VIRGINIA ELECTRIC & POWER COMPANY

SURRY POWER STATION UNIT NO. 2

Amendment No. 11
License No. DPR-37

CHANGE NO. 26 TO THE TECHNICAL SPECIFICATIONS

FIGURE 3.12-1A CONTROL BANK INSERTION LIMITS FOR 3-LOOP NORMAL OPERATION-UNIT 1

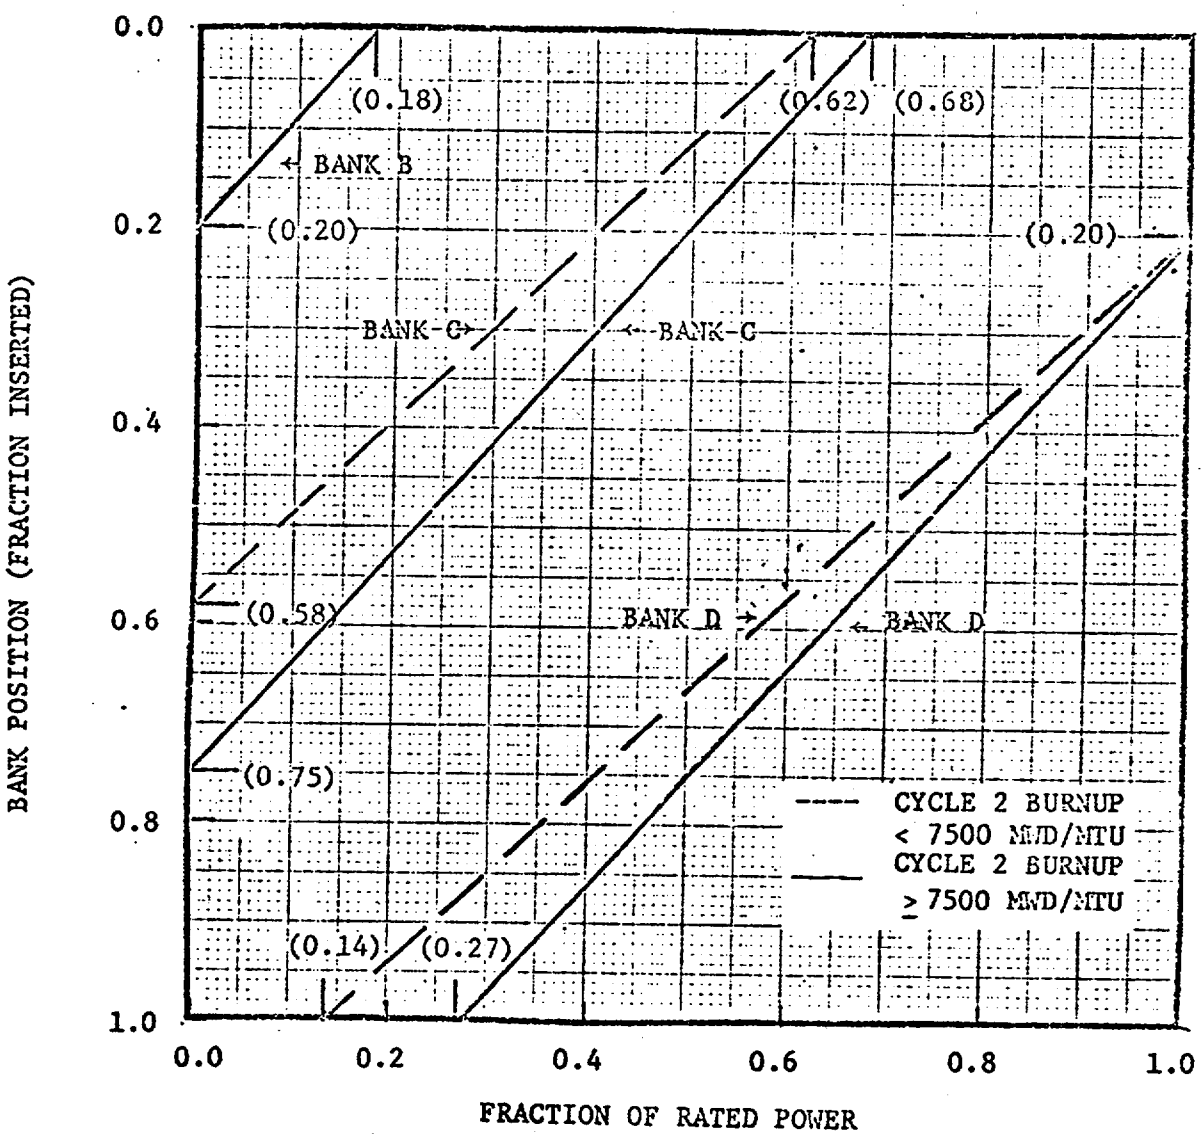
2. Control rod banks are sequenced with overlapping banks as shown in Figures 3.12-1A, 3.12-1B and 3.12-2.

ROD BOW PENALTY
SURRY POWER STATION
UNIT 1

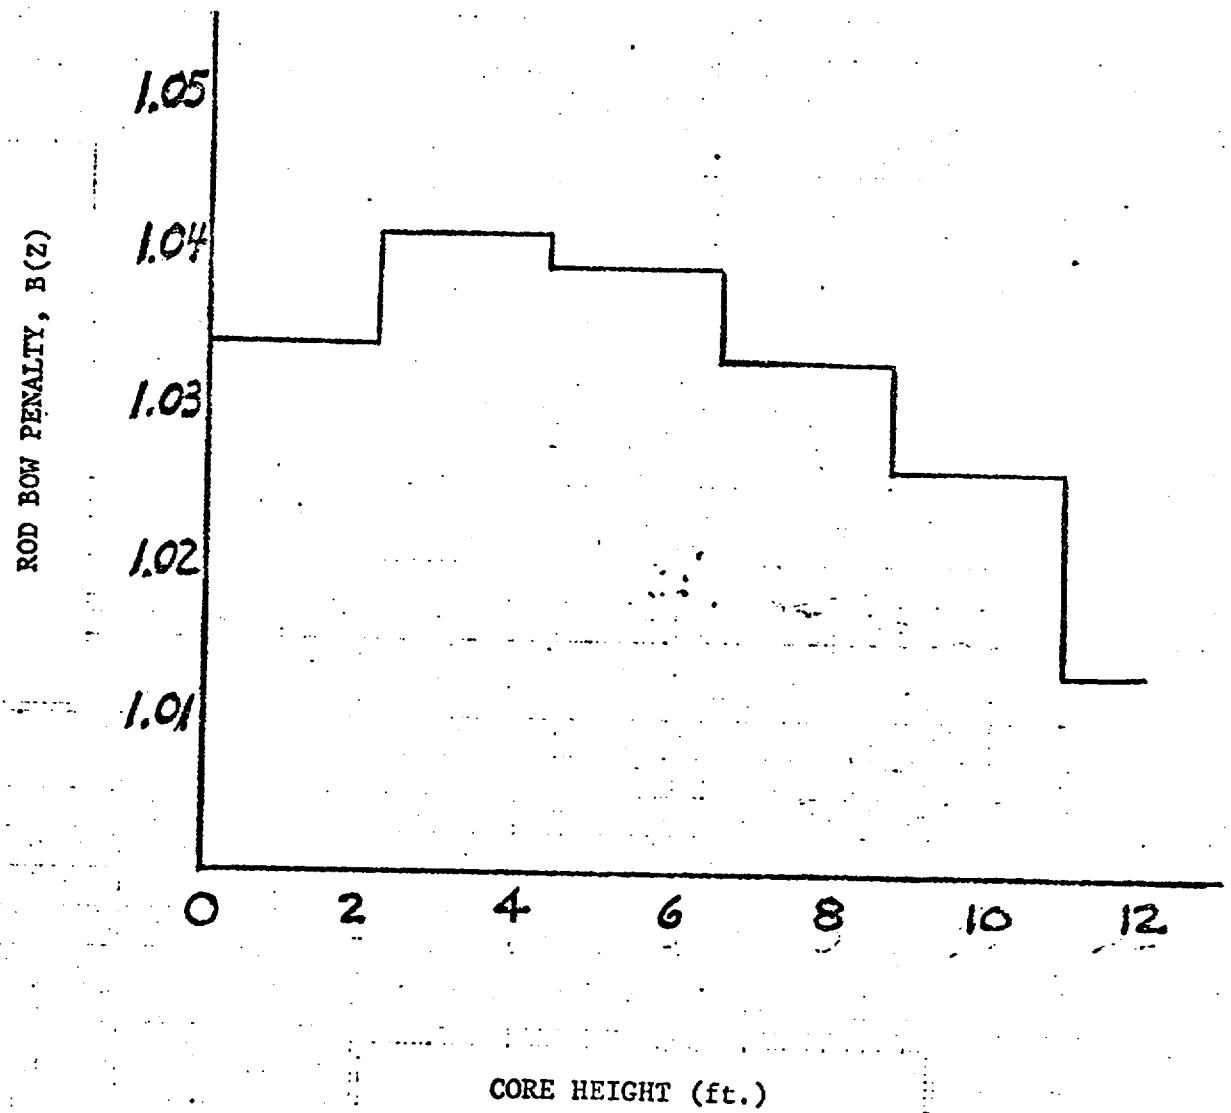
where B(Z) is the rod bow penalty as a function of axial core elevation shown in TS Figure 3.12 -9, and the other parameters in the above equation are defined in the basis. The surveillance on $F_j(Z)$ will be performed by measuring the normalized axial power distribution, $F_j(Z)$, from thimble j at core elevation Z utilizing at least two timbles of the moveable incore flux system for which $\overline{R}$, as defined in the basis, has been determined. This shall be done immediately following and as a minimum at
